REQUEST FOR AGENDA PLACEMENT FORM	
Submission Deadline - Tuesday, 12:00 PM before Court Dates	
SUBMITTED BY: David Disheroon TODAY'S DATE: 07/29/2021	
DEPARTMENT :	Public Works
SIGNATURE OF DEPARTMENT HEAD:	
REQUESTED AGENDA DATE:	08/09/2021
SPECIFIC AGENDA WORDING: Review of Flood Study for 8700 E FM 917, by Halff Associates, and Consideration of Recommendations.	
PERSON(S) TO PRESENT ITEM: David Disheroon	
SUPPORT MATERIAL: (Must enclose supporting documentation)	
TIME: 10 minutes	ACTION ITEM: X WORKSHOP
(Anticipated number of minutes needed to discuss item) CONSENT: EXECUTIVE:	
STAFF NOTICE:	
COUNTY ATTORNEY: X IT DEPARTMENT:	
AUDITOR: PURCHASING DEPARTMENT: PERSONNEL: PUBLIC WORKS: X	
BUDGET COORDINATOR: OTHER:	
********This Section to be Completed by County Judge's Office*******	
ASSIGNED AGENDA DATE:	
REQUEST RECEIVED BY COUNTY JUDGE'S OFFICE	
COURT MEMBER APPROVAL	Date

Re: Orr Expansion – 8700 FM 917 – Flood Study Review #1

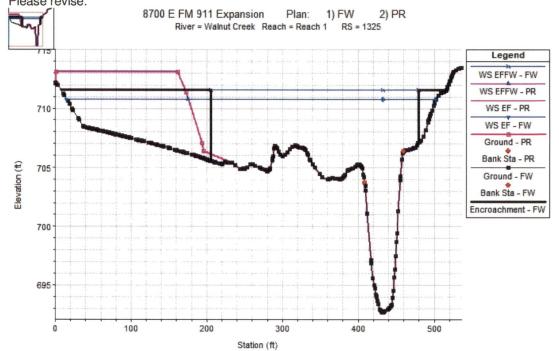
6. Cross Sections 1161, 1325, and 1461 show fill extending beyond the toe of the main slope and into the modeled floodway. See screenshot of 1325 below. There should not be any fill in the floodway. Please revise.
